IMPORTANT SAFETY NOTICE

SUBJECT: All RIDGID® 700 Power Drives and Replacement Switches (Catalog #44905) produced between April, 2006 and September, 2007:

November 12, 2007

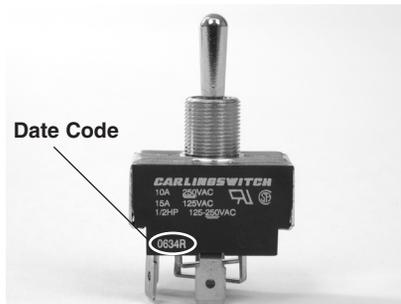
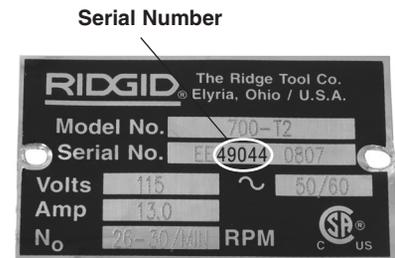
ON/OFF/REV Switch

Serial Plate

Serial Number

This is a Product Recall Notice. Ridge Tool recently determined that the catalog #44905 ON/OFF/REV switch installed in these 700 Power Drives can stick in the ON or REV position during use. This could result in the user **losing control of the power drive and result in severe injury.**

All 700 Power Drives produced between April, 2006 and September, 2007 are potentially effected by this issue. Affected 700 Power Drives can be identified by checking the serial number of the 700 Power Drive. If the serial number falls in the range from 36764 through 49537 (as shown in the above photographs), the unit must be disassembled and the switch inspected. If the switch has a date code of 0613 up to and including 0736 (see above switch photo for typical date code location), the switch must be replaced. Switches in this date code range cannot be inspected or tested for correct operation. All switches in this date code range must be replaced and the switch destroyed.

Do not use these 700 Power Drives until they have been reworked with a correct switch.

Contact Ridge Tool Technical Services at (800) 519-3456 or TechServices@ridgid.com for instructions to rework the affected product.
